H.1.a.k **505, 517, 519/521 Quadra Street and 931 Convent Place – Rezoning Application No. 00610 & Development Permit with Variance No. 00088 (Fairfield)**

F.3 505, 517, 519/521 Quadra Street and 931 Convent Place - Rezoning
Application No. 00610 & Development Permit with Variance No. 00088
(Fairfield)

Committee received a report dated August 23, 2018 from the Director of Sustainable Planning and Community Development presenting Council with information, analysis and recommendations for a Rezoning and a Development Permit with Variances Applications for the properties located at 505, 517, 519/521 Quadra Street and 931 Convent Place.

1 PARKADE PLAN
A200 SCALE: 1/32"

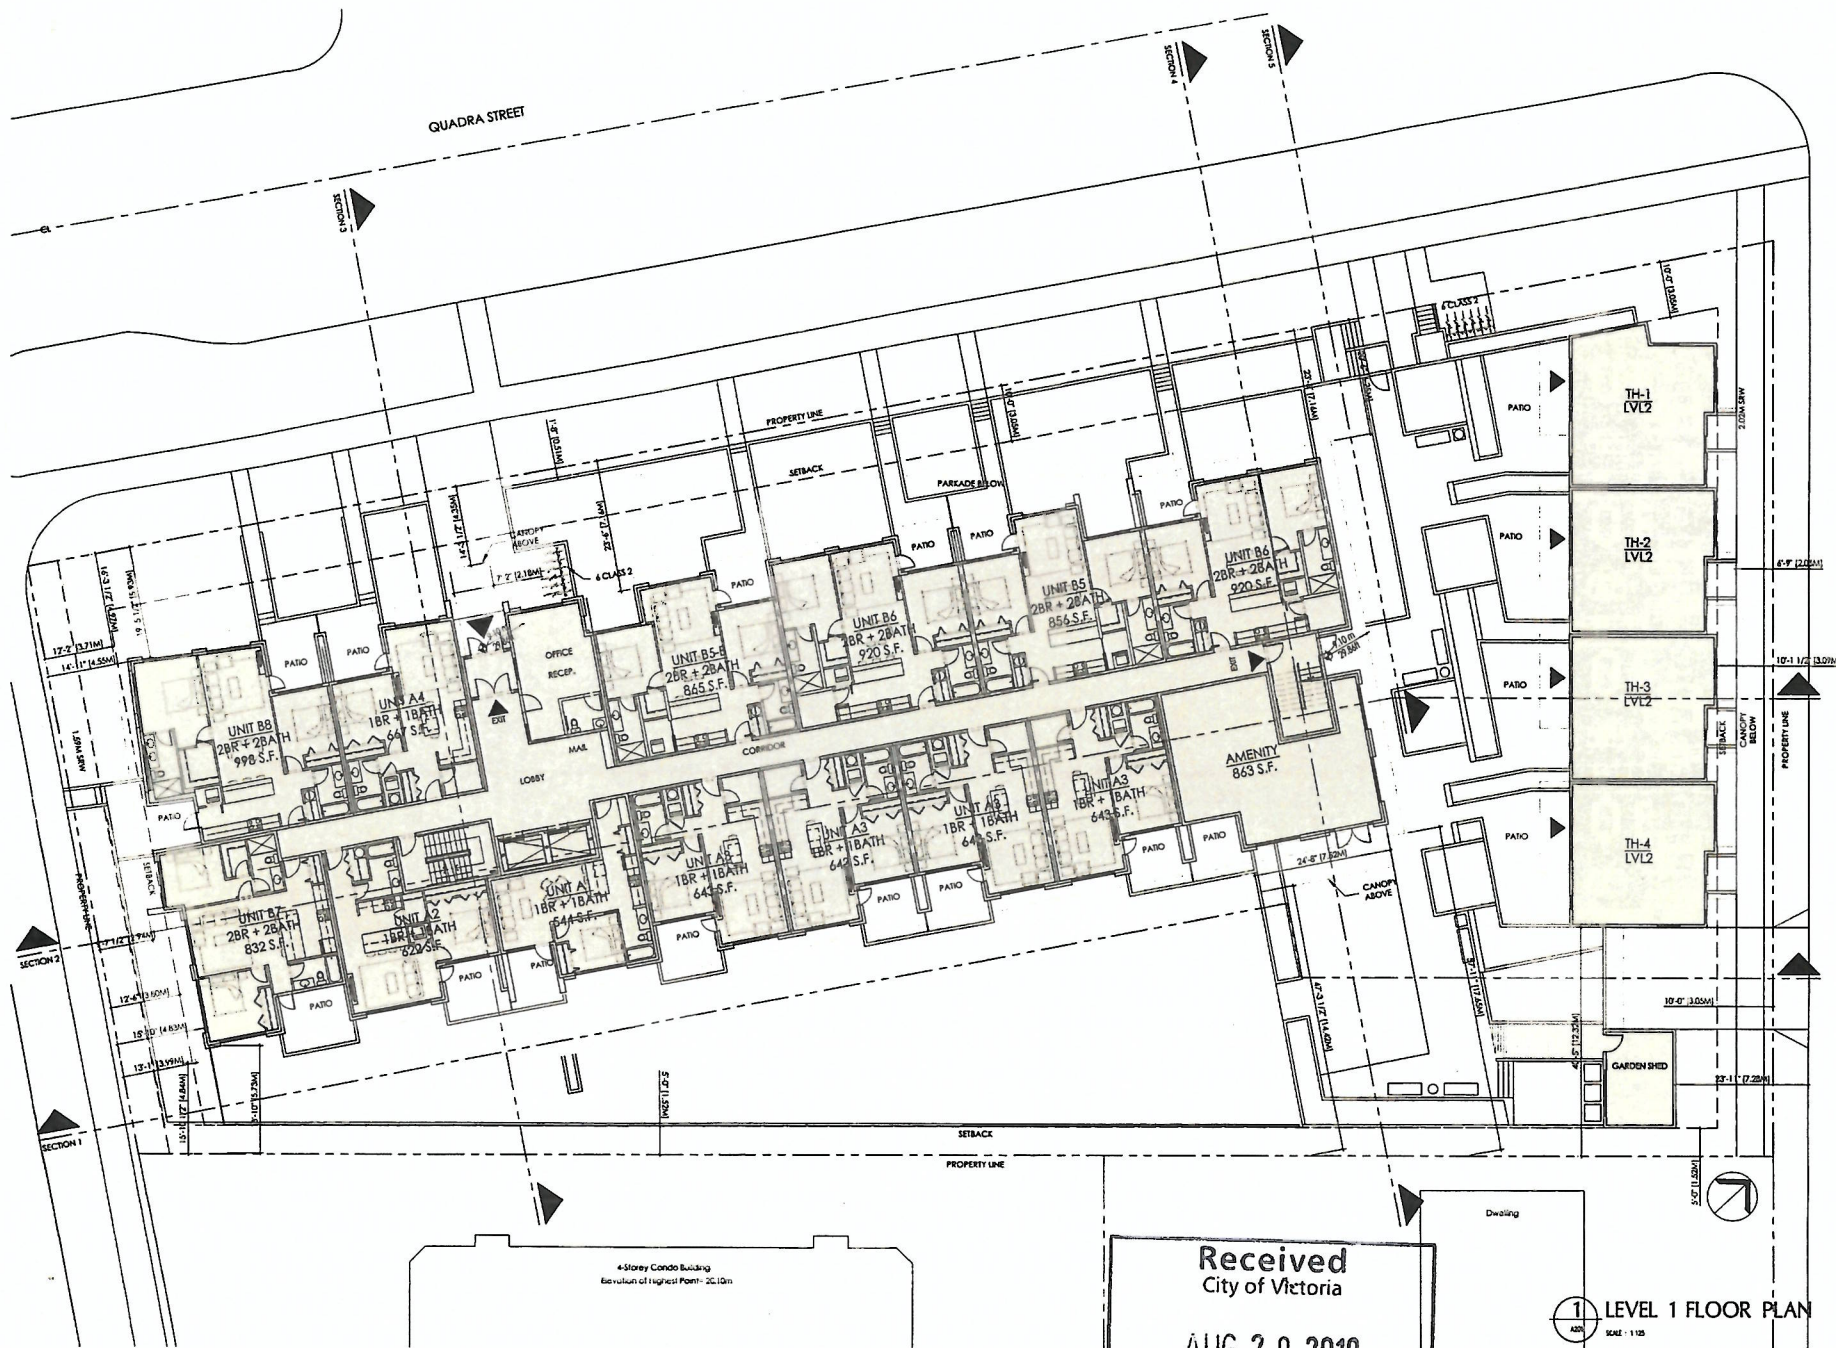
- how does the bicycle access work?
 - there are two access points; one requiring a fob from the parkade entrance and another on Quadra Street
- A200 shows stairs to the bicycle access – is this correct?

- yes, and there is a ramp beside the stairs that isn't shown on the plans
- what properties to the east have higher density, as referenced in the presentation?
